VOGTLE ELECTRIC GENERATING PLANT
REQUEST TO REVISE TECHNICAL SPECIFICATIONS
REVISION TO REACTOR PRESSURE LIMITS

MARKED UP TECHNICAL SPECIFICATION PAGES

VOGTLE ELECTRIC GENERATING PLANT REQUEST TO REVISE TECHNICAL SPECIFICATIONS REVISION TO REACTOR PRESSURE VESSEL LIMITS

EXEMPTION REQUEST

Figure 3.4-2a

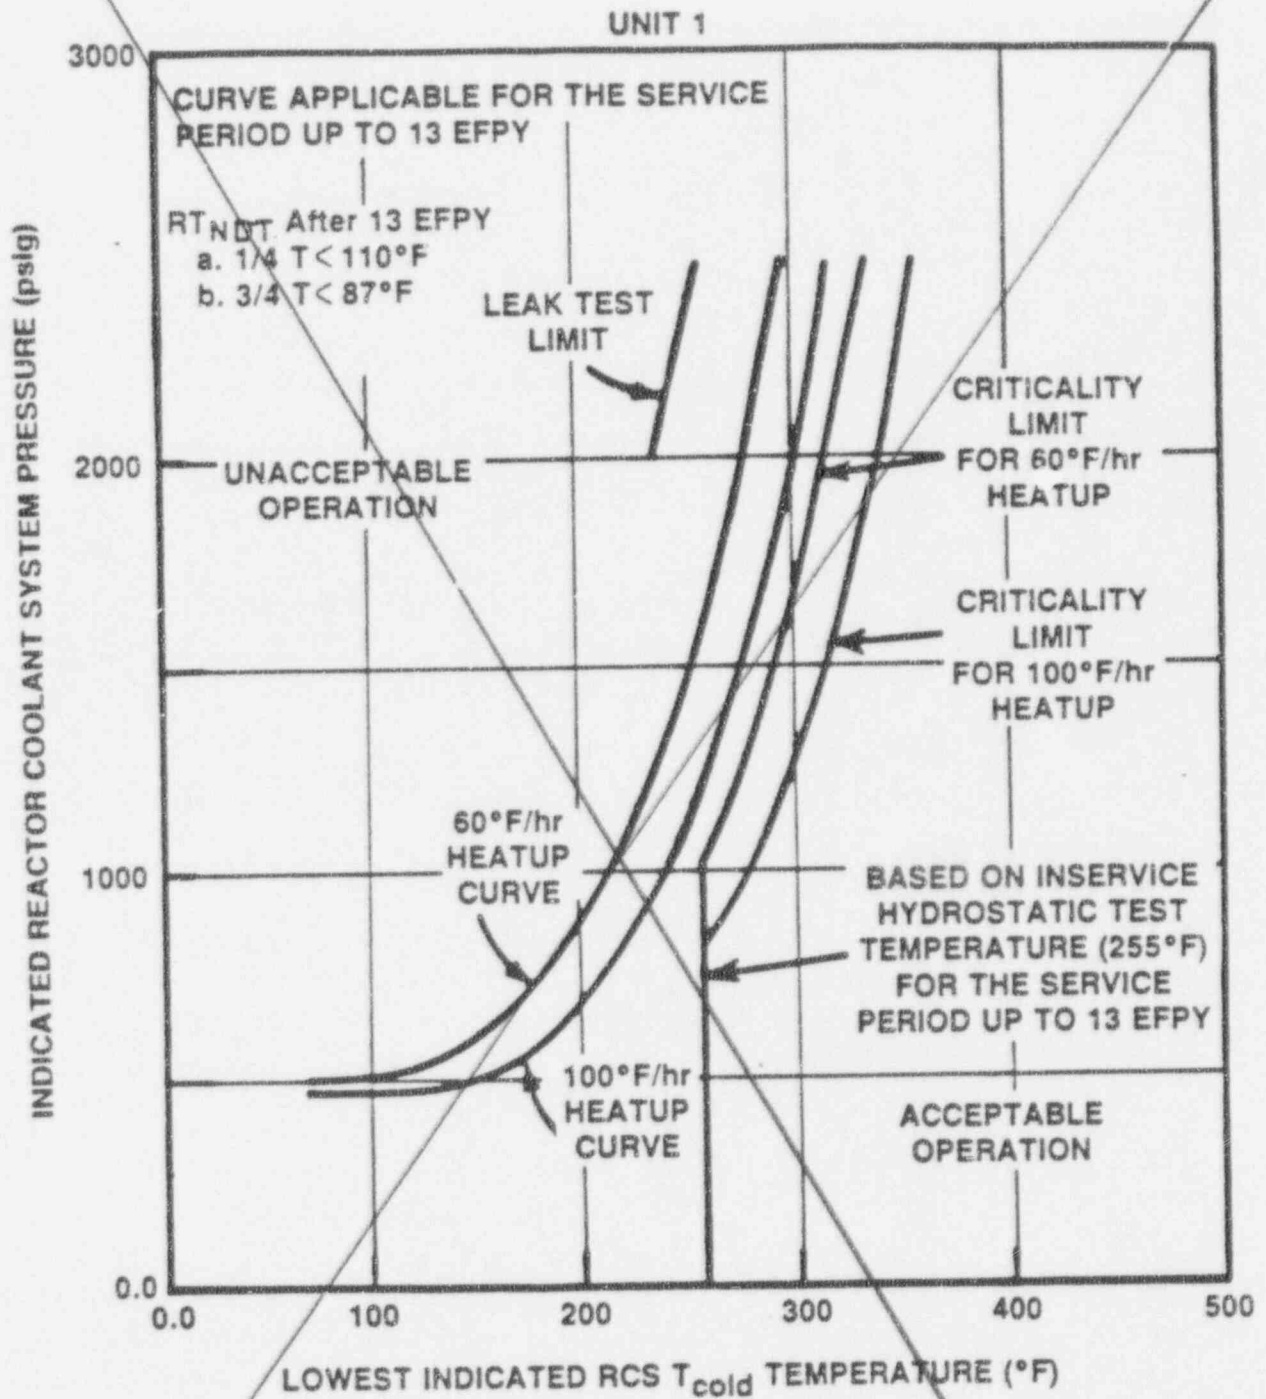
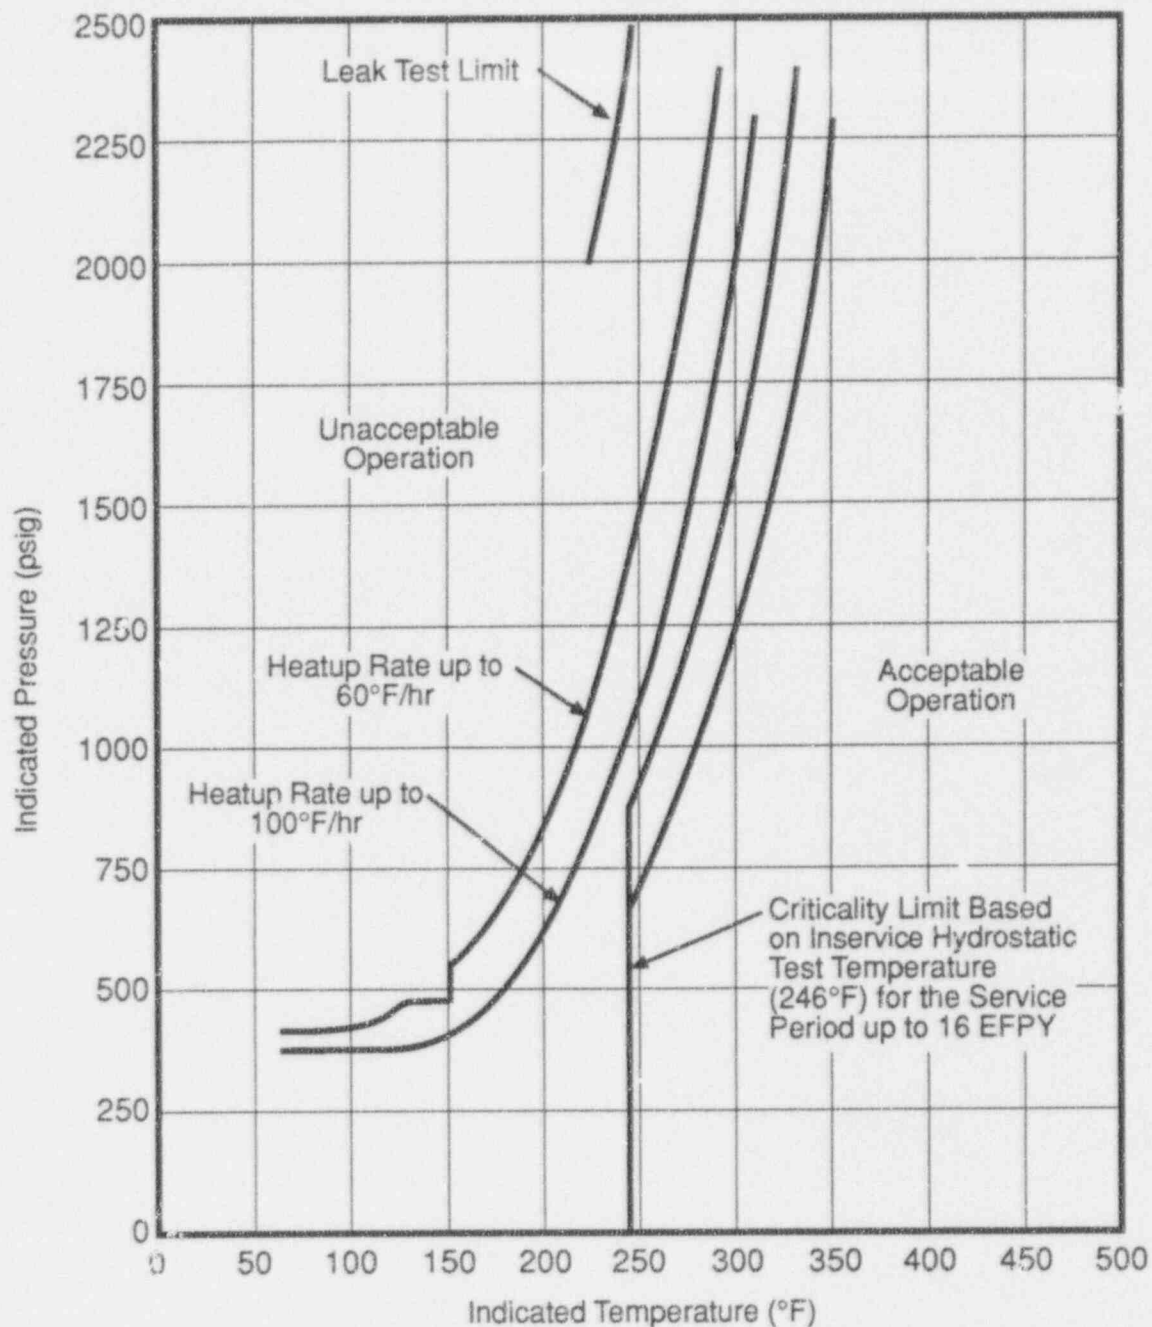
REPLACE WITH NEW PAGE 3/4 4-31

RT_{NDT} After 13 EFY @ 1/4 T < 110°F
@ 3/4 T < 87°F

Copper Content:	Assumed - NA WT% (Actual - 0.083 WT%)
RT _{NDT} Initial:	Assumed - NA °F (Actual - 20°F)
RT _{NDT} At 16 EFY:	@ 1/4T = 100.7°F @ 3/4T = 84.1°F

Unit 1 Reactor Coolant System Heatup Limitations (Heatup rates up to 100°F/hr) Applicable for the First 16 EFY (With Margins of 10°F and 60 psig for Instrumentation Errors and Margin of 74 psig for Pressure Difference Between Pressure Instrumentation and Reactor Vessel Beltline Region).

Figure 3.4-2b

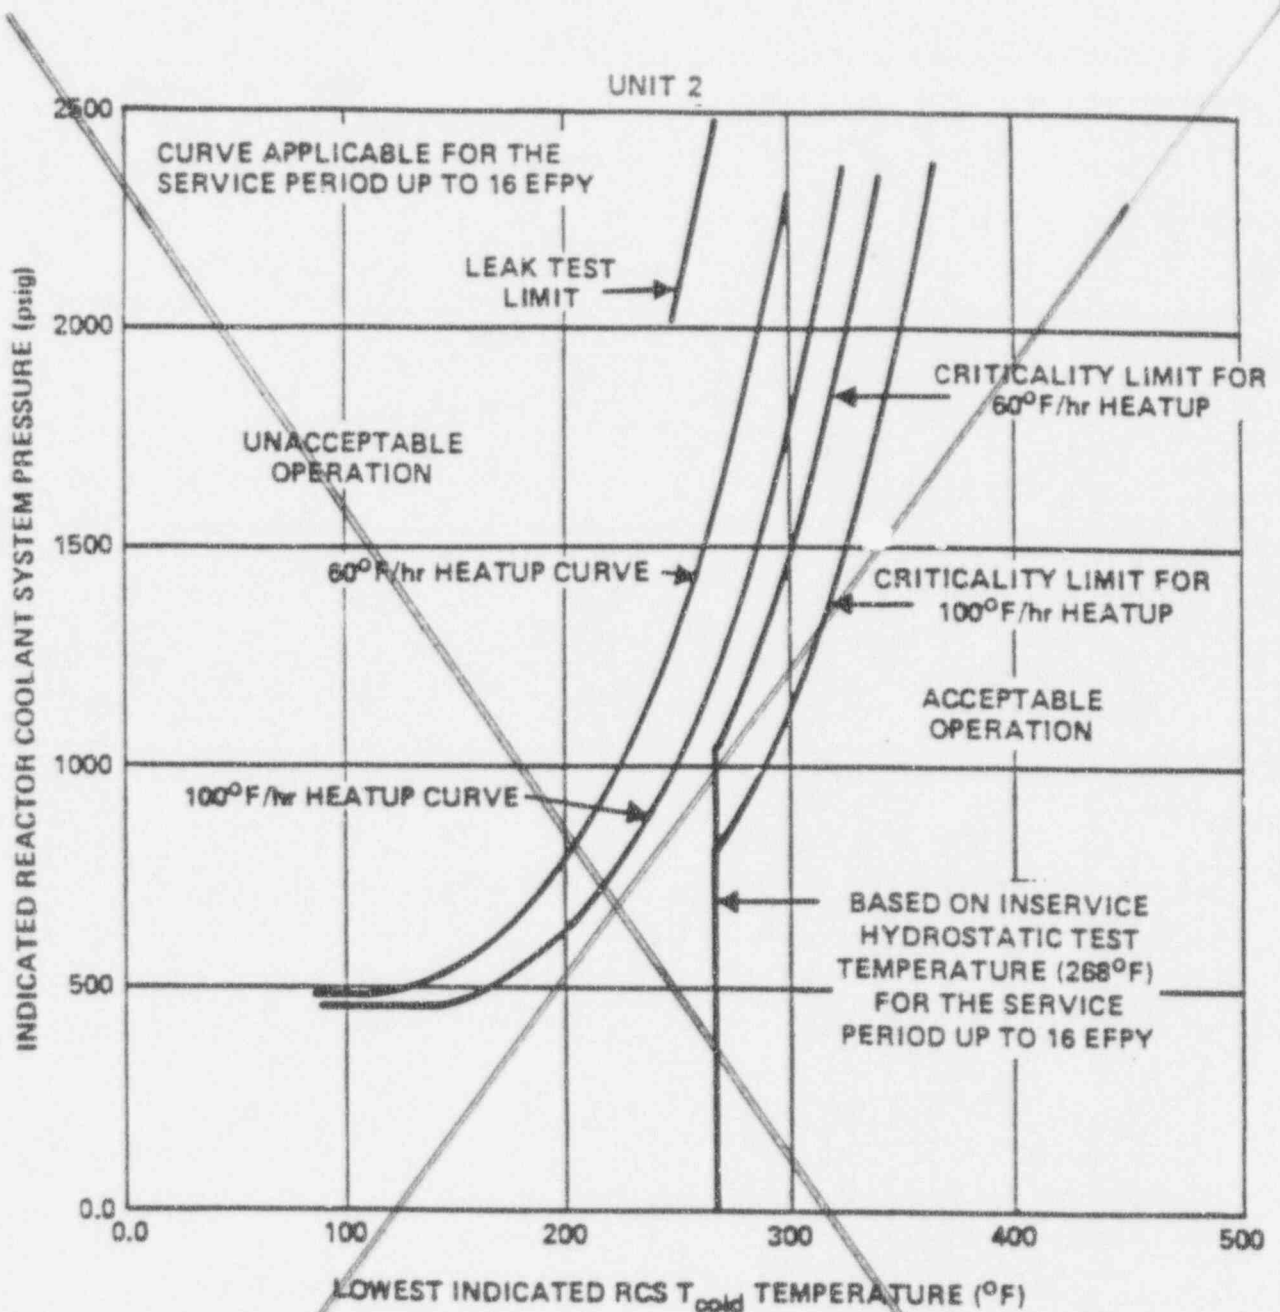
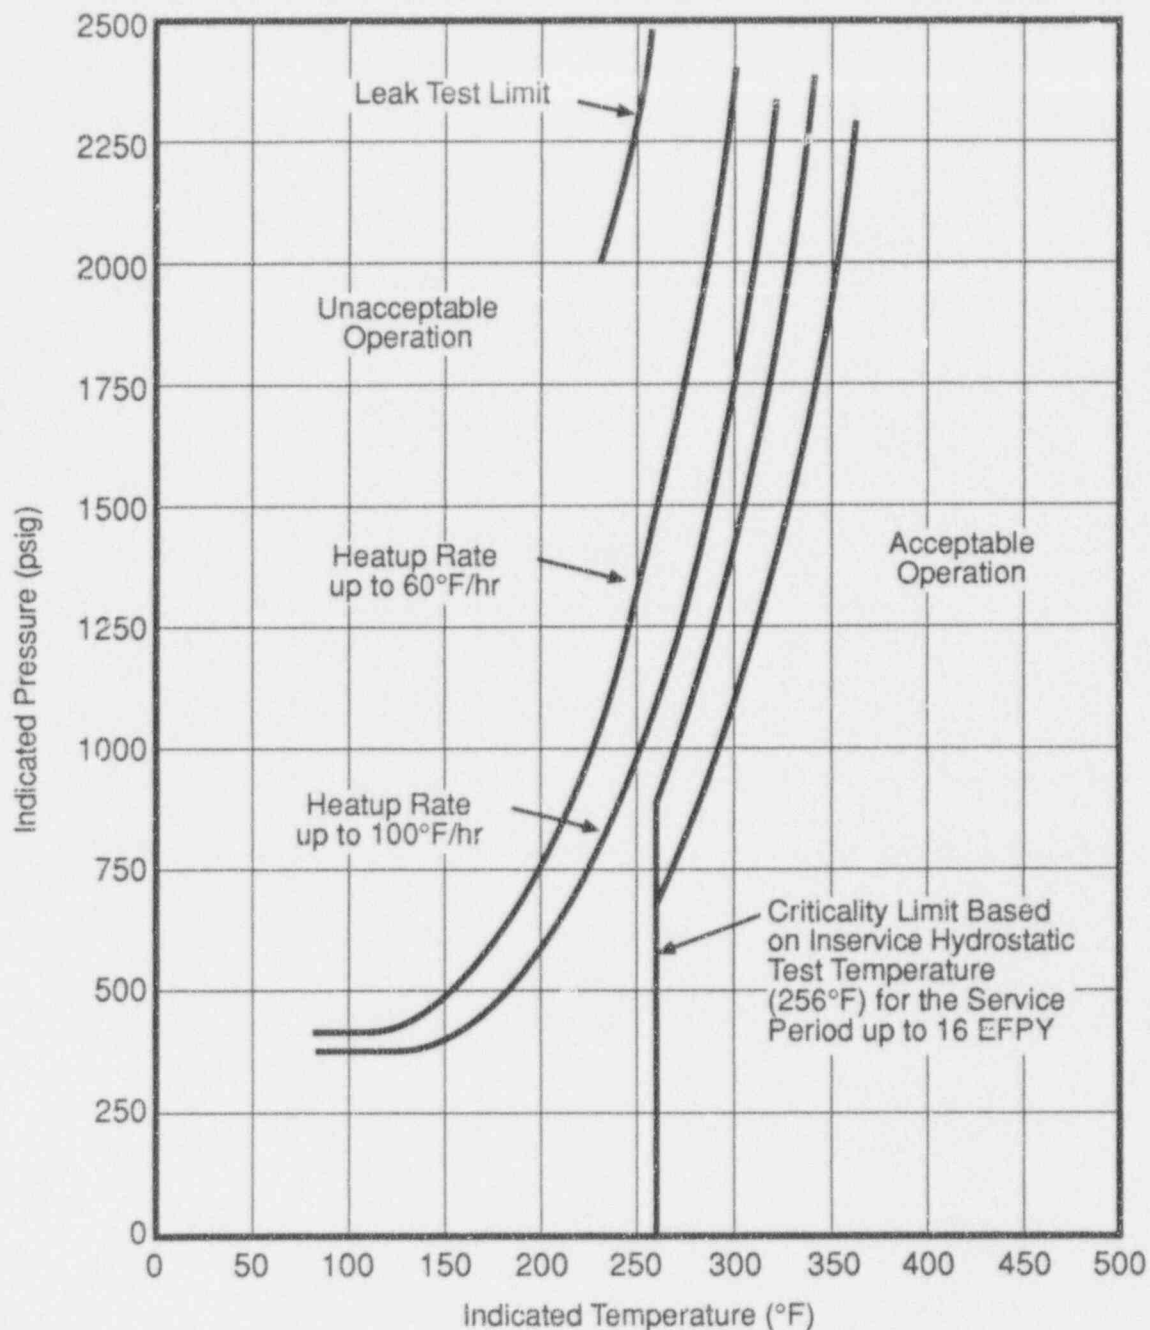
REPLACE WITH NEW PAGE 3/4 4-31a

RT_{NDT} After 16 EFPY @ 1/4 T = 123 °F
@ 3/4 T = 97 °F

RT_{NDT} At 16 EFPY: @ 1/4T = 112°F
@ 3/4T = 94°F

Unit 2 Reactor Coolant System Heatup Limitations (Heatup rates up to 100°F/hr) Applicable for the First 16 EFPY (With Margins of 10°F and 60 psig for Instrumentation Errors and Margin of 74 psig for Pressure Difference Between Pressure Instrumentation and Reactor Vessel Beltline Region).

Figure 3.4-3a

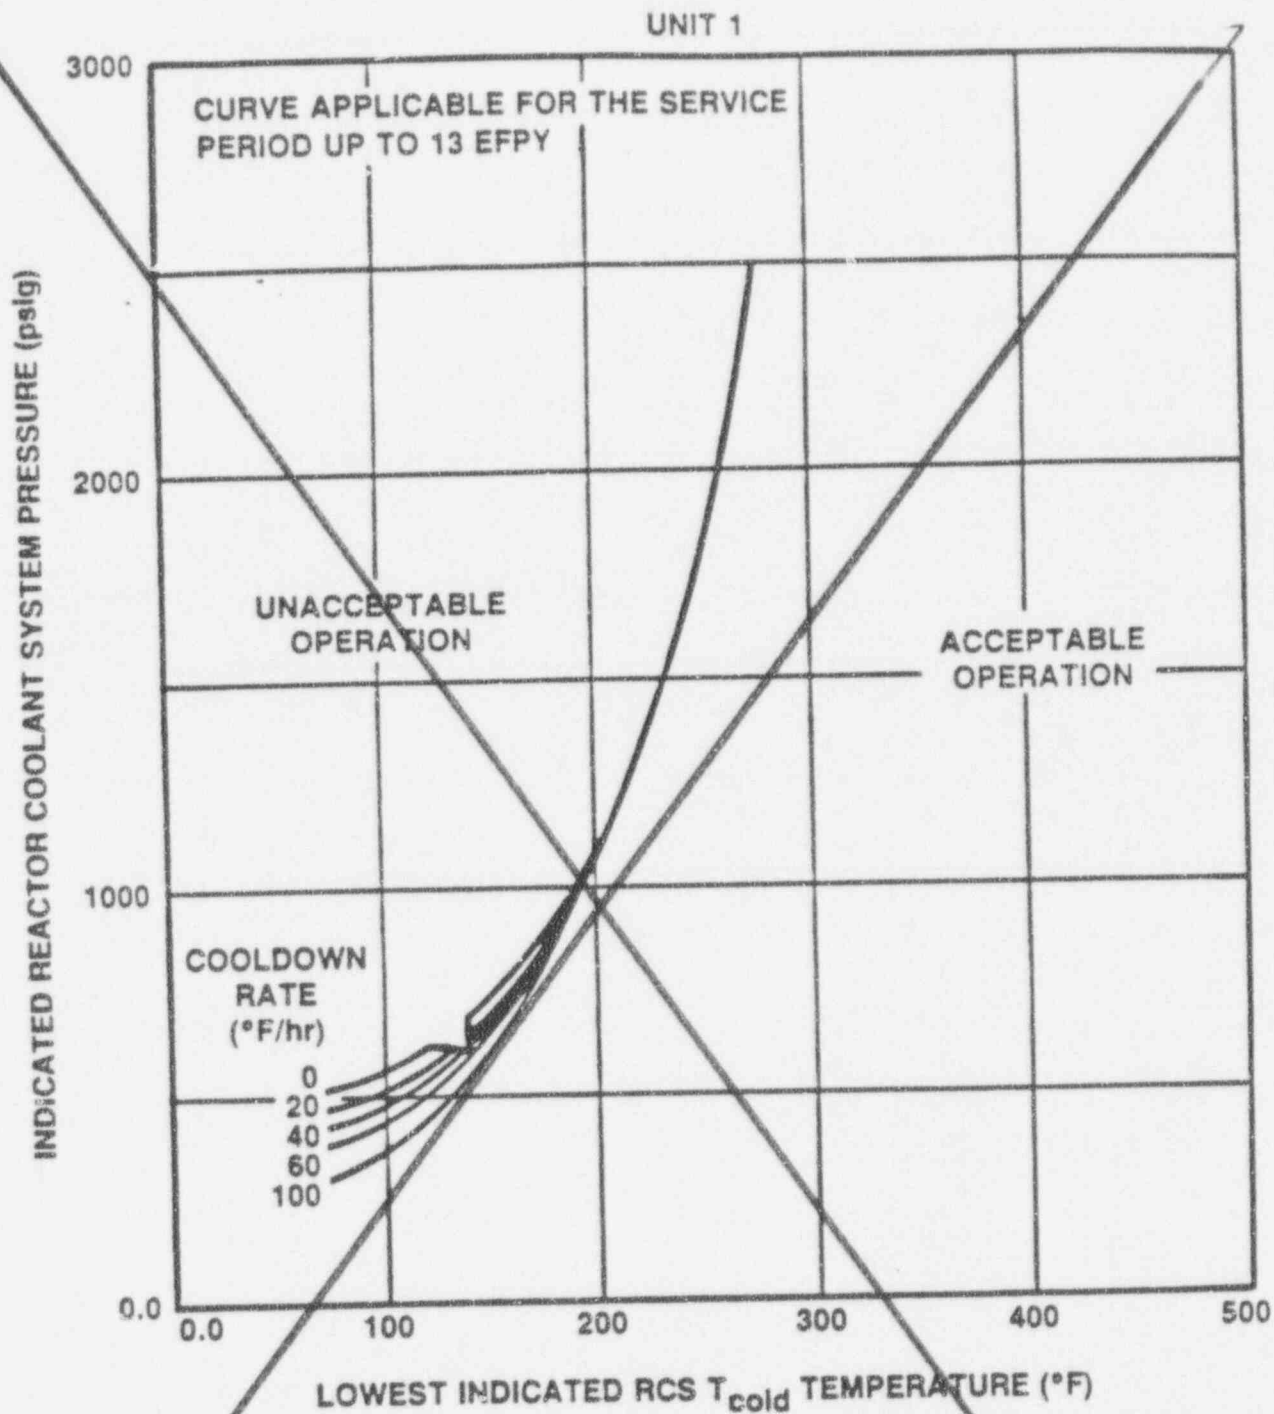
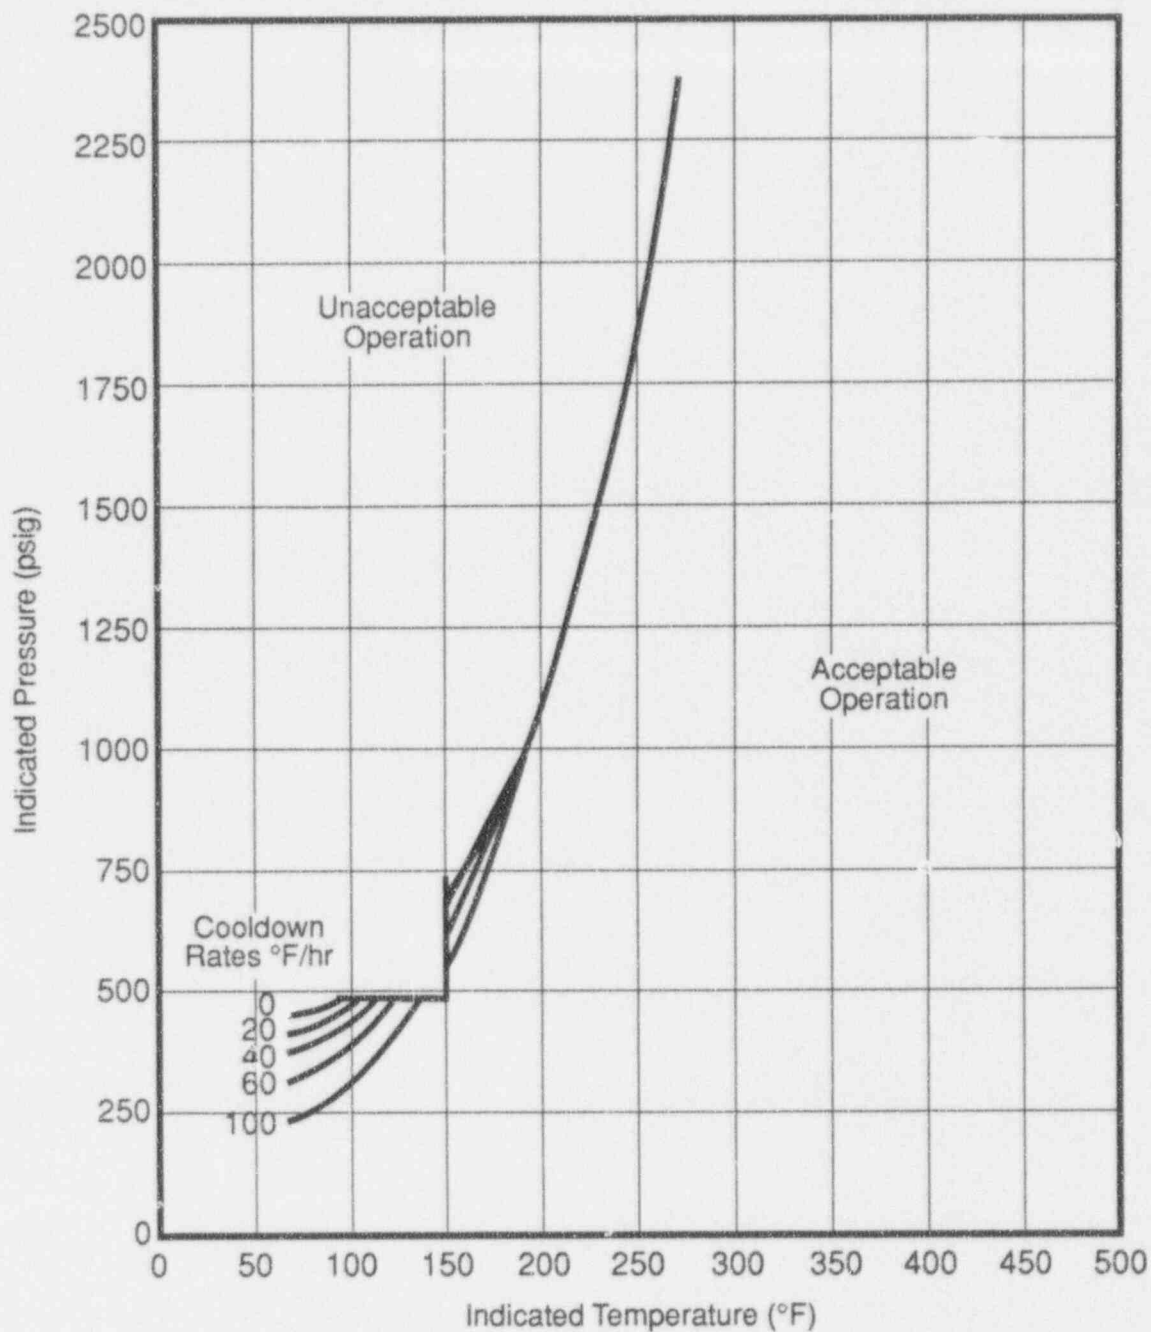
REPLACE WITH NEW PAGE 3/4 4-32

RT_{NDT} After 13 EFY @ 1/4 $T \leq 110^\circ F$
@ 3/4 $T \leq 127^\circ F$

Copper Content: Assumed - NA WT%
(Actual - 0.083 WT%)
RT_{NDT} Initial: Assumed - NA °F
(Actual - 20°F)
RT_{NDT} At 16 EFPY: @ 1/4T = 100.7°F
@ 3/4T = 84.1°F

Unit 1 Reactor Coolant System Cooldown Limitations (Cooldown rates up to 100°F/hr)
Applicable for the First 16 EFPY (With Margins of 10°F and 60 psig for Instrumentation
Errors and Margin of 74 psig for Pressure Difference Between Pressure Instrumentation
and Reactor Vessel Beltline Region).
